Re: Petition for Reconsideration of "Determination of No Hazard to Air Navigation"

With regard to: **2013-AWP-5595-OE**
2013-AWP-5596-OE
2013-AWP-5597-OE
2013-AWP-5598-OE

Impact of Ground Illumination Sources and Marine Layer on Approach to San Diego International Airport (SAN) Runway 9

Figure 2 – Satellite Image with SAN, approach and Point Loma High School

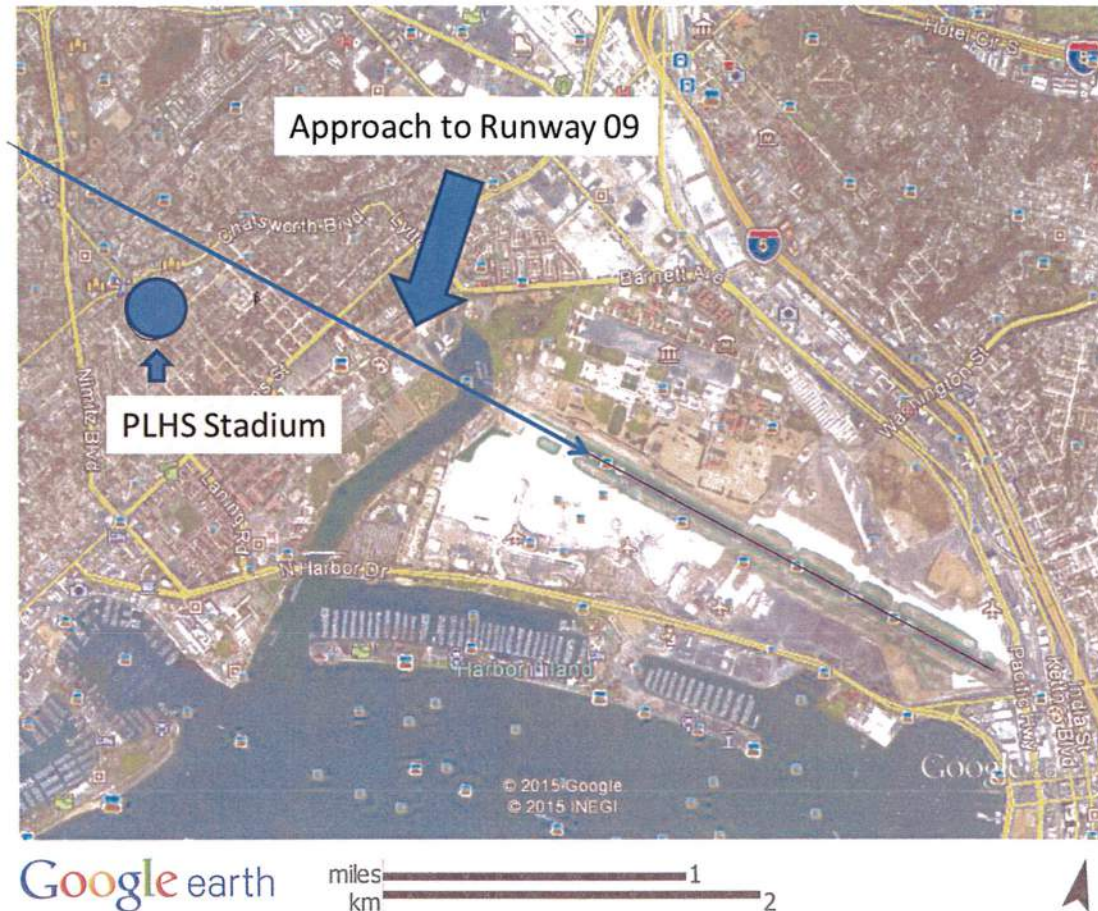
The location of Point Loma High School with respect to SAN is shown in Figure 2 (a snapshot from Google Earth) with the SAN approach path to Runway 09 outlined.

Figure 3 – Runway 09 Airspace Surfaces Profile
 SAN_AirportLandUseCompatibilityPlan-2014.pdf

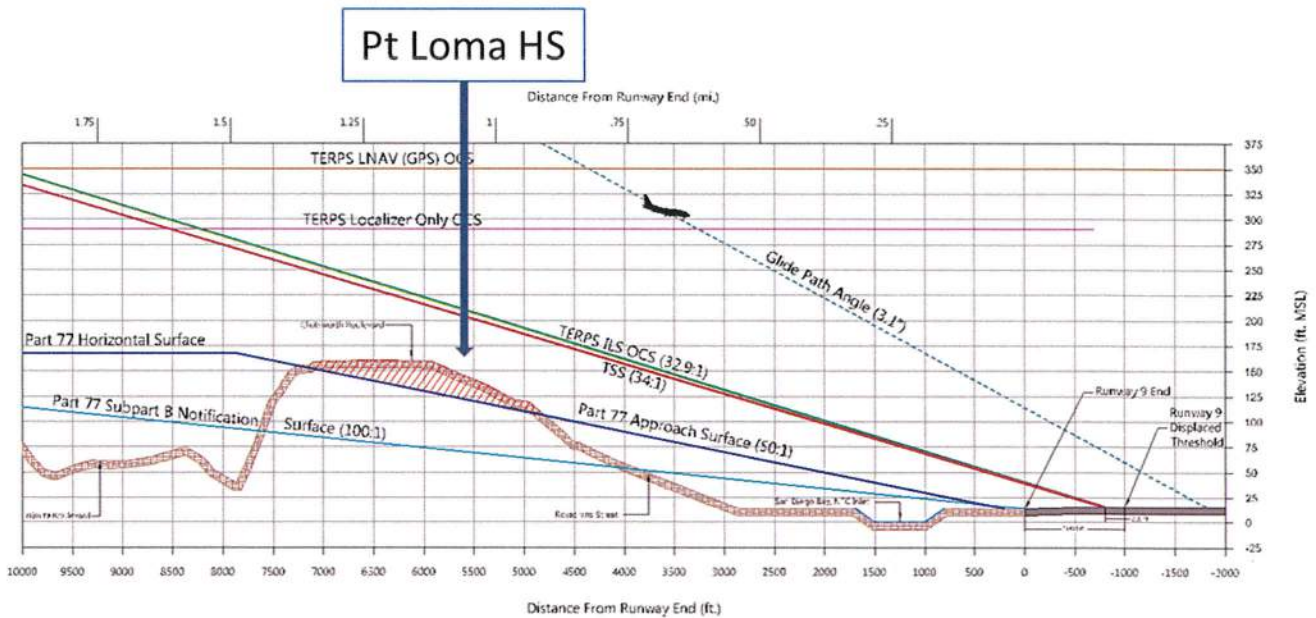
The location of Point Loma High School is flagged in Figure 3 but is still above the Part 77 Approach Surface and therefore any development at the site must be assessed for impact on aircraft operations at SAN. An initial assessment was made and the results place restrictions on the height of stadium lights installed at the stadium at the high school. The initial assessment of the airspace geometries have resulted in an upper height restriction of the light standards at the high school stadium to be less than 60-72 feet.

The initial assessment did not address potential impact of the lighting itself on any approach requirements.
